LANEY COLLEGE TITLE IX LOCKER ROOM RENOVATION PROJECT

ADDENDUM FOUR

RFP NO. 19-20/11

Peralta Community College District

Site Logistics Plan- Possible Staging/Laydown area map

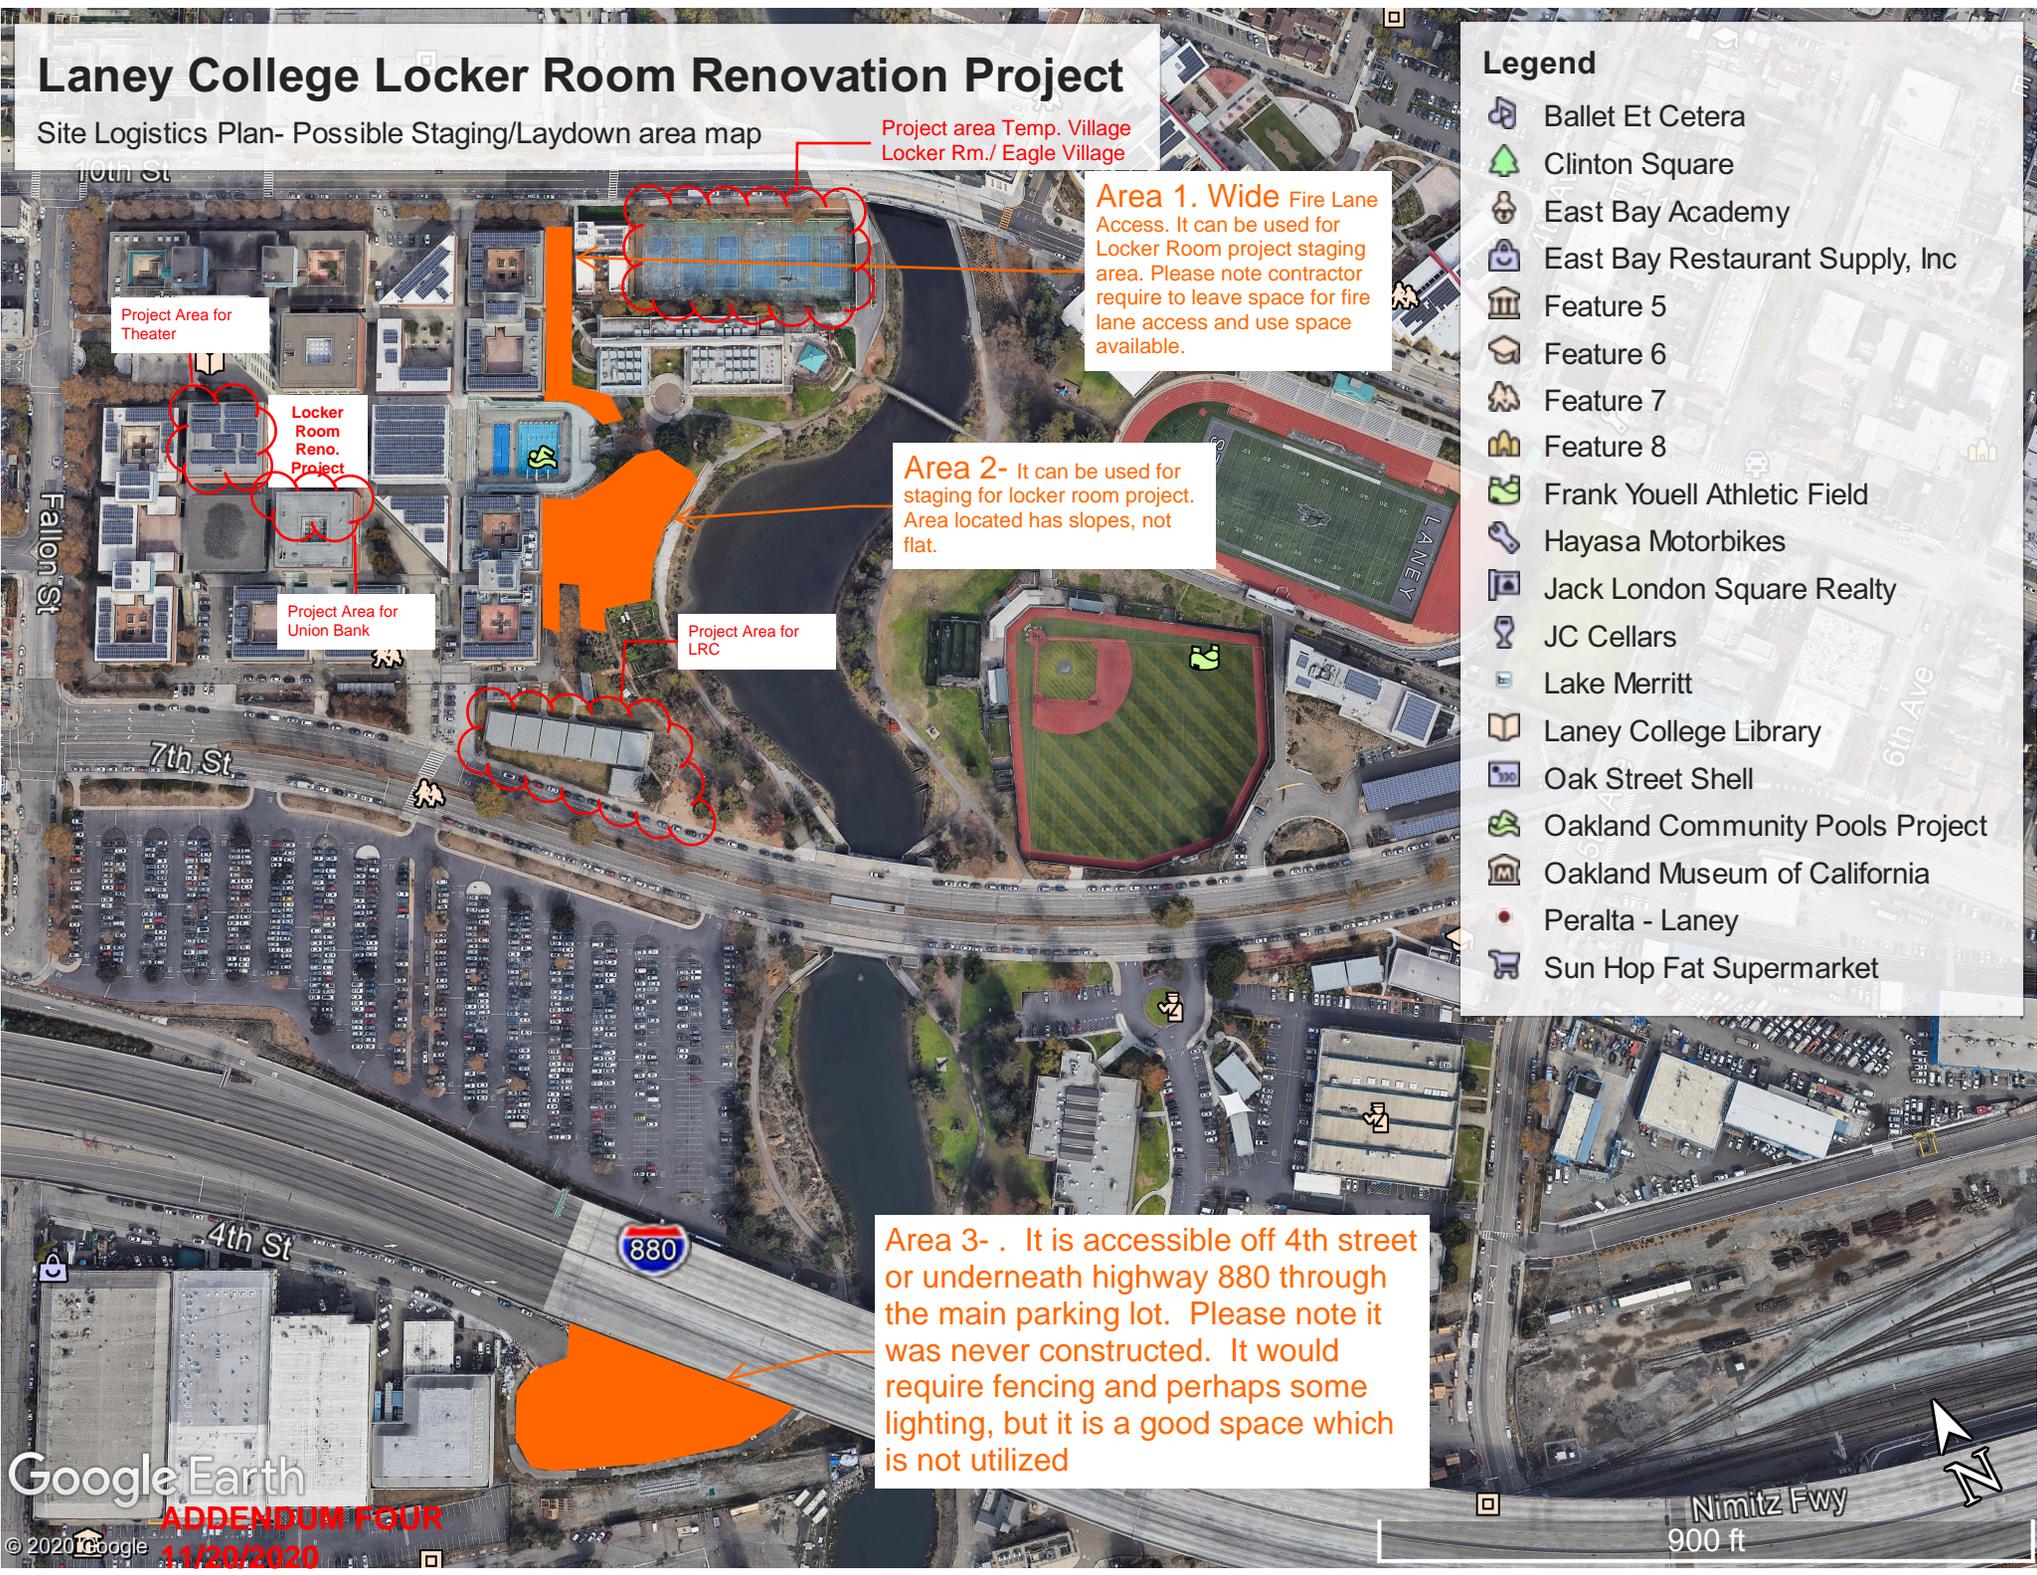
1. **Site Logistics & Laydown area.**
 - a. **What are the current spaces available to stage for construction?**
See the site diagram attached to this Addendum.

- b. **What areas adjacent to the construction site would need to remain available for access by students and faculty?**
An area adjacent to the Gymnasium is currently used by students; the dance studio is currently in use near the women's locker room; and the pool is now used by some team). See the site diagram attached to this addendum.

Area 1. Wide Fire Lane Access. It can be used for Locker Room project staging area. Please note contractor require to leave space for fire lane access and use space available.

Area 2- It can be used for staging for locker room project. Area located has slopes, not flat.

Area 3- It is accessible off 4th street or underneath highway 880 through the main parking lot. Please note it was never constructed. It would require fencing and perhaps some lighting, but it is a good space which is not utilized
